JAFNPP

IMPROVED STANDARD TECHNICAL SPECIFICATIONS (ISTS) CONVERSION

ITS: 5.5

**MARKUP OF NUREG-1433, REVISION 1
SPECIFICATION**

5.5.8 Ventilation Filter Testing Program (VFTP) (continued)

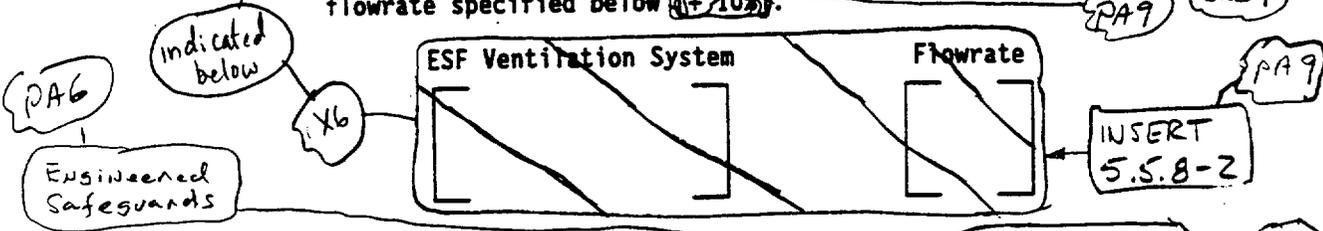
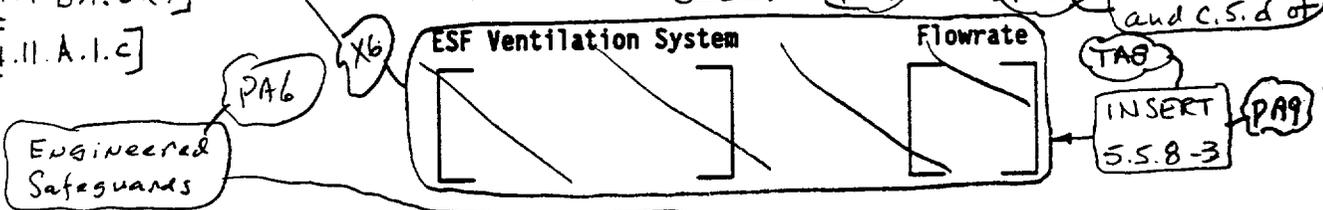
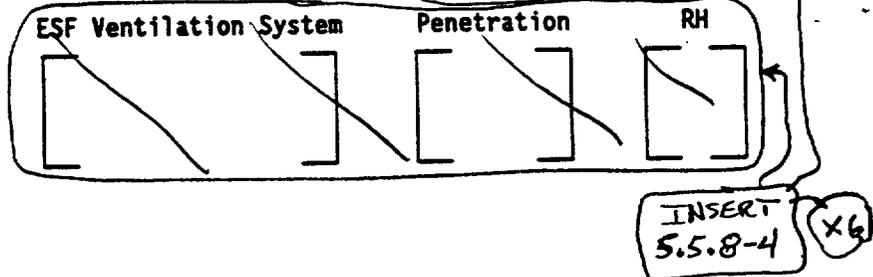
a. Demonstrate for each of the ESF systems that an in-place test of the HEPA filters shows a penetration and system bypass $\leq 0.05\%$ when tested in accordance with Regulatory Guide 1.52, Revision 2, and ASME N510-1989 at the system flowrate specified below (+10%).

b. Demonstrate for each of the ESF systems that an in-place test of the charcoal adsorber shows a penetration and system bypass $\leq 0.05\%$ when tested in accordance with Regulatory Guide 1.52, Revision 2, and ASME N510-1989 at the system flowrate specified below (+10%).

c. Demonstrate for each of the ESF systems that a laboratory test of a sample of the charcoal adsorber, when obtained as described in Regulatory Guide 1.52, Revision 2, shows the methyl iodide penetration less than the value specified below when tested in accordance with ASTM D3803-1989 at a temperature of $\leq 30^\circ\text{C}$ and greater than or equal to the relative humidity specified below. (86°F)

- CLB7 ITS 5.5.8.c has been revised to reflect the current JAFNPP requirement in CTS 4.7.B.1.c and CTS 4.11.A.2 that charcoal absorber samples are obtained as described in Section C.6.b of Regulatory Guide 1.52, Revision 2 and that the minimum temperature for analysis is 30°C or 86°F.

- CLB9 ITS 5.5.8.a and ITS 5.5.8.b have been revised to reflect the current licensing basis. The HEPA filters and charcoal adsorbers in the Standby Gas Treatment (SGT) and Control Room Emergency Ventilation Air Supply (CREVAS) Systems were designed and constructed to ANSI/ASME N509-1976, Nuclear Power Plant Air Cleaning Units and Components. ASME N510-1980 is the appropriate standard for testing the SGT and CREVAS System HEPA filters and charcoal adsorbers.
